926 North Beverly Drive

STAFF REPORT
CITY OF BEVERLY HILLS

**For the Design Review Commission
Meeting of September 2, 2010**

SUBJECT: A request for an R-1 Design Review Permit to allow the construction of a new two-story single-family residence, located in the Central Area of the City, north of Santa Monica Boulevard at **926 North Beverly Drive.** (PL#1020001)

Reviewed Project – 8/5/10

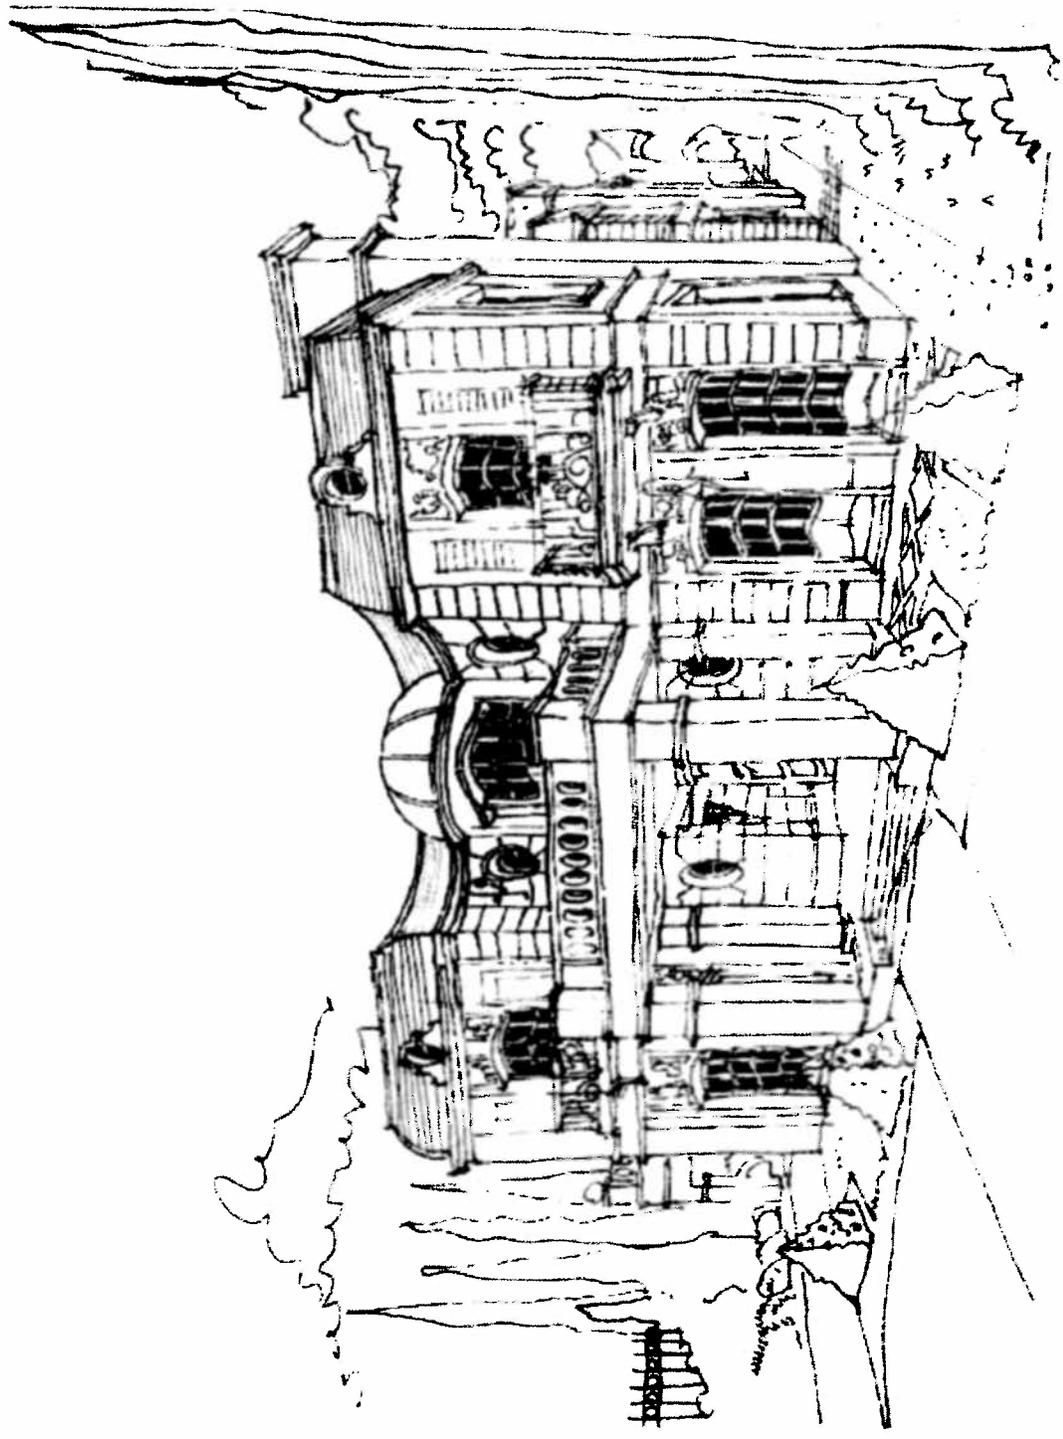
<p align="center">Design Review Commission Comments August 5, 2010</p>	<p align="center">Applicant's Response</p>
<ul style="list-style-type: none"> ➤ The front façade needs to be refined. ➤ The portico element in the center of the front façade seems out of place. ➤ The mass and shape of the portico along the front façade is not consistent with classically design. ➤ Consider removing the patio/portico along the front façade. ➤ The Commission expressed concern about the proposed design fitting into the streetscape and requested to see the scale of the project is comparison to existing residences on the street (streetscape). ➤ The Commission requested to see more details of the proposed façade. 	<ul style="list-style-type: none"> ➤ The portico at the front of the residence has been redesigned. ➤ The applicant has provided a rendering which incorporates the proposed residence into the existing streetscape. ➤ The applicant has provided pictures of large, two-story single-family residences in the neighborhood with similar massing and scale as the proposed design. ➤ The applicant has provided details and examples of the proposed façade elements.
